Shearwater Petrel 1 & 2/Perdix/Perdix AI/NERD 2 Firmware v65 Release Notes

Rev: A

Date: 2019-01-18

Surface GF is the gradient factor if you were to instantly ascend to the surface

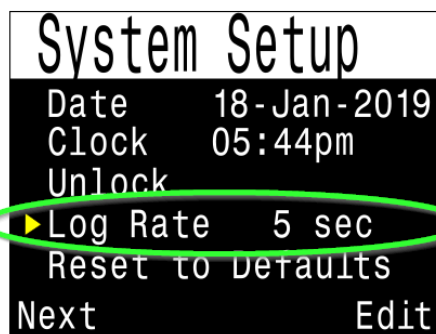
NEW FEATURE (All models): Surface GF display added. This shows the gradient factor if you were to surface immediately. This is different from GF99, which shows your gradient factor at the current depth. Is available:

- On the standard info screens (i.e. after a few right button presses).
- Can be configured on open main screen locations.
- Can be configured as the NDL replacement (appears in-place of NDL once deco is needed)

Log Rate can be set to 2, 5, or 10 seconds

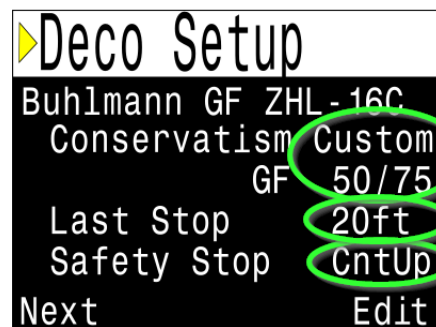
NEW FEATURE (All models): Log sampling rate can be set to 2, 5, or 10 seconds (previously always 10 seconds). Note that log downloads may take longer with faster sampling rates as more data is being recorded. Also, less logs can be stored until they are overwritten. For example, about 1000 hours are stored at a 10 second rate, but only 200 hours at a 2 second rate.

NOTE: When downloading to legacy log software (e.g. old Shearwater Desktop or third-party programs) the dive computer will down convert the log to a 10 second rate for backwards compatibility. Downloading at faster rates requires using Shearwater Cloud v2.2.2 or higher. Third-parties may offer download and display of the faster rates in the future.

New OC Rec Deco Options

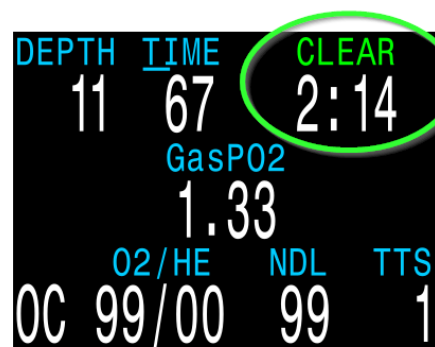
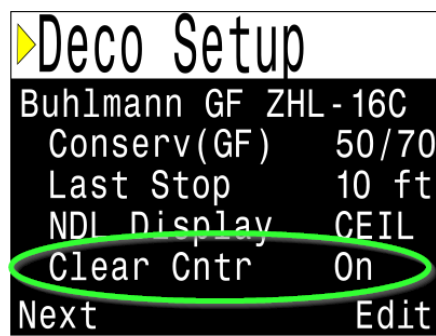
IMPROVEMENT (OC Rec mode only): Allows user to set customized gradient factors in OC Rec mode. Previously only fixed sets were available in OC Rec mode.

IMPROVEMENT (OC Rec mode only): Allows user to select a 20ft/6m last stop depth in OC Rec mode. Previously the last stop was always 10ft/3m in OC Rec mode.

NEW FEATURE (All models): A “Deco Clear” up-counter option has been added.

Available in OC Tec, CC/BO, and OC Rec modes. In OC Rec mode it is available in place of the safety stop. Optional in Tec modes.

When deco clears this counter begins counting up from 0. It is useful for timing additional padding after the mandatory decompression stops. If the dive did not need deco, then begins upon entering the safety stop zone (i.e. shallower than 20ft / 6m).

The “Clear Counter” counts up once deco is clear

The “OC MOD PPO2” replaces “OC Max PPO2” with different behaviour. Please read the description to left!

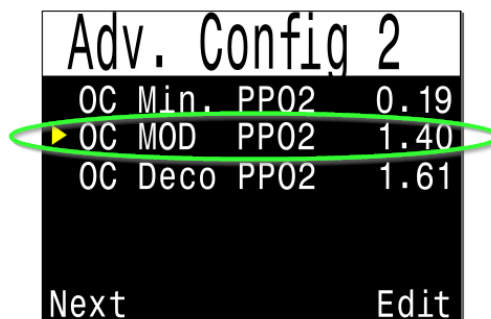
CHANGE (All models): The PPO2 limit options have been changed for OC Tec mode.

Previously, there was an “OC Max PPO2” setting which only defined when the “High PPO2” message occurred, regardless of dive phase (e.g. bottom depth or at deco stop). This confused many users who, quite reasonably, assumed it was the “bottom depth” limit and set it to 1.40. This would result in warnings during deco when the PPO2 was pushed to the 1.60 range.

The “OC Max PPO2” has now been removed and replaced with a “OC MOD PPO2” setting. The MOD setting only applies to the bottom depth phase. The dive computer automatically switches to using the “OC Deco PPO2” limit when within 2 stops of the next deco stop. The “OC Deco PPO2” limit also sets where predictive deco gas switches occur. Also, if the current gas has greater than or equal to 80% oxygen fraction, then the deco limit is used, as the gas is assumed to be a deco gas.

After updating, the “OC MOD PPO2” value is set to 1.40 ATA and the “OC Deco PPO2” is unchanged.

The CC diluent is red to indicate it is unsafe to breathe directly (PPO2 > 1.60)

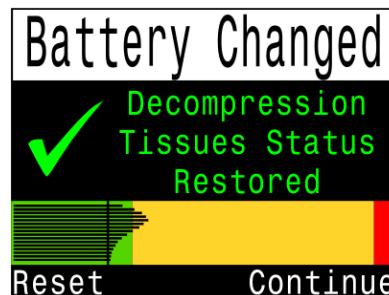
NEW FEATURE: The gas will display in flashing red when its PPO2 is outside of a safe breathing range (i.e. below the min PPO2 or above the max PPO2 setting).

In CC mode, this warning refers to the diluent only. The breathing loop PPO2 may be in a safe range, but if the diluent is unsafe to breathe directly then the gas will be red. Note that other warnings exist to warn when the breathing loop is outside of a safe range.

The tissues bar graph is now shown on the Tissues Restored screen

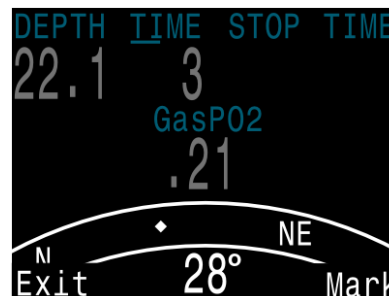
NEW FEATURE: After changing the battery, the current deco tissue loading is shown on the Tissues Restored screen.

NEW FEATURE: On the Tissues Restored screen, a shortcut to reset the tissues is given. If Reset is chosen, a prompt will be displayed to confirm.

The mark heading command now requires less button presses

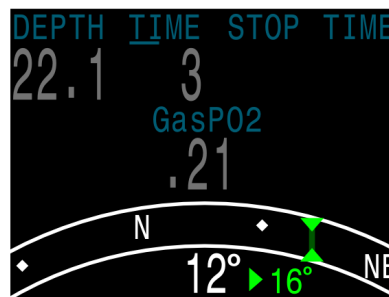
CHANGE: Compass mark heading menu moved to reduce button presses. Also, the compass can now be viewed while marking. Operation: when viewing compass a left button press brings up an “Exit Mark” menu. Right press marks compass, Left press exits to main screen. Previously had to navigate to regular menus to mark the compass.

Cave brightness is very dim and thus best suited for dark environments like caves

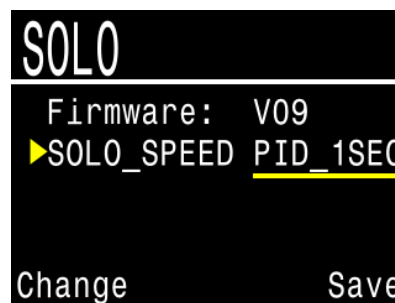
NEW FEATURE: New “Cave” brightness setting. This is even dimmer than Low brightness, and is suitable for very dark environments like caves.
